UNITED STATES PATENT AND TRADEMARK OFFICE

Office Action Summary	Application No. 10/577,497	Applicant(s) PETERS, WILLEM JOZEF LODEWIJK	
	Examiner IYAD TOOM	Art Unit 3744

DETAILED ACTION

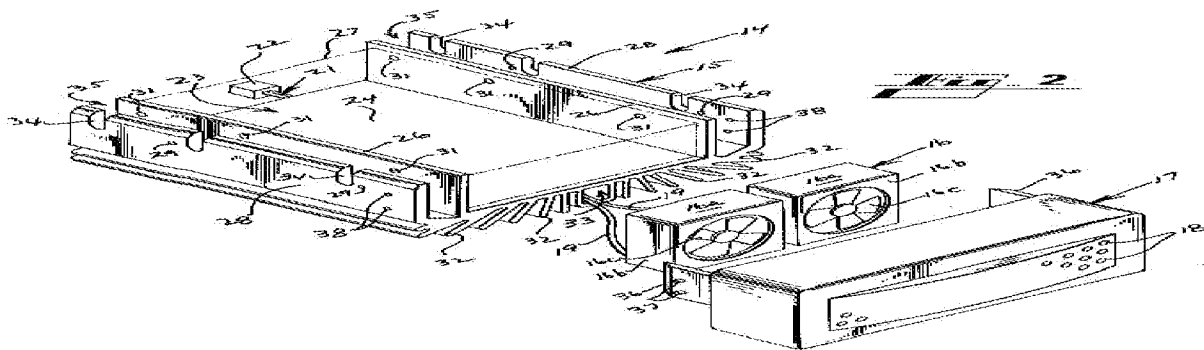
Claim 10 objected to because of the following informalities: Claim 10 recites the limitation "the motor of the tool" in line 2, correct to --a motor of the tool--

Appropriate correction is required.

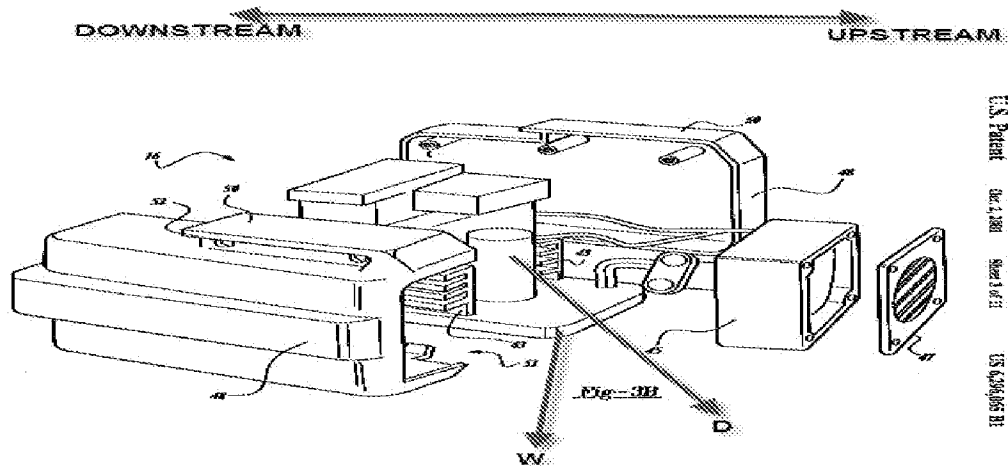
Claim 1 is rejected under 35 U.S.C. 102(b) as being anticipated by Lin, US Patent No. 5,927,386.

In regard to claim 1, Lin discloses in fig. 2 above, an electric switch unit 14 comprises heat dissipating components 32, characterized in that the switch unit 14 comprises a fan 16a which is adapted to cool the heat dissipating components (this is functional recitation in which the fan 16a is capable of performing).
